North Hertfordshire District Council

Building Conservation comments

File Ref: 24/02060/FPH & 24/02061/LBC

Address: Julians, Julians Park, Rushden, Buntingford, Hertfordshire, SG9 0TD

Detail of the replica horizontal sliding sash window and brickwork.

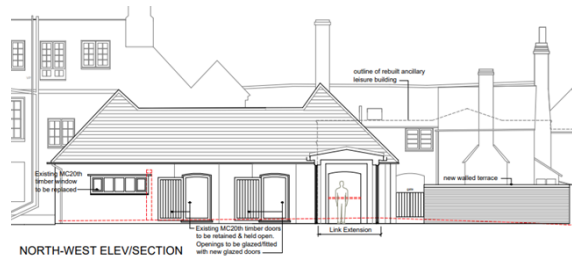
2.4 Whilst the pool building is undoubtedly larger and would physically connect with the service wing resulting in the loss of a 24-pane window and brickwork below (see photo below), the design of the link is such that I consider its impact has been kept to a minimum ensuring to an extent, a sense of visual separation for the pool building.

2.10 To address SPAB's objection to the proposed interventions within the Butler's Pantry Corridor, consideration could be given to retaining existing doors, cupboards and panelling. I appreciate that I previously stated a "consequence of removing the C20 partitions forming the Butler's Pantry/Laundry, the amended layout provides the opportunity to reinstate the C17 fireplace and bressummer beam to the proposed kitchen and dining area". However, I can be convinced of an alternative approach offered by SPAB which is to do less, and I am not entirely convinced that to reinstate an overmantle in what would be an opened-up space adjacent to the external doorway leading to the Butler's Pantry Corridor is fully justified. Not interfering with this space would enable two existing doors to also be retained in-situ (see 2.7).

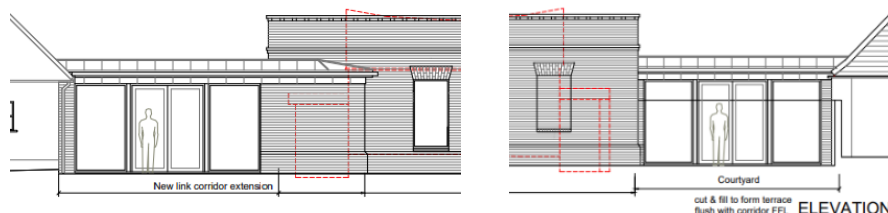
The introduction of fully glazed doors to the south elevation is problematic. The harsh visual properties of an unbroken expanse of glass can be a stark contrast with the surrounding historic brickwork. We therefore encourage the applicant to consider a design that incorporates smaller glass panels within a timber frame if there is a need to introduce more light to the internal space. We are also not convinced that the rehanging of the historic doors onto parliament hinges would work well in practice, further detailed drawings should be provided to show the impact that the proposals will have on the historic fabric.

- 4.2 I note the point made here and if the doors are set on parliament hinges, I assume it would be the inner face of the doors which would appear externally against the building. I am less perturbed by the fully glazed doors which, whilst contrasting, would not in my view be harmful. It is noted that due to the projecting brickwork surrounds, only part of each door would sit completely flush against the brickwork. Alternatively, I am prepared to consider, for instance, stable doors in these openings which could be fully or part-opened in good weather.

- 4.3 As stated previously, the handling of the pool link is such that it reads in design terms as a visually 'lighter weight' structure that will provide an acceptable link between the pool building and host building. As discussed with the architect, a condition could be imposed stating that this link should not receive blinds or any treatment to the glazing.

- 4.4 I previously queried as to how the timber braces in the images below relate to new fabric and that internal elevations would be welcome as part of a formal submission. An internal elevation is provided but it lacks the clarity of detail to

be able to make an informed decision without imposing a condition. It is understood that a more detailed internal elevation will be prepared.
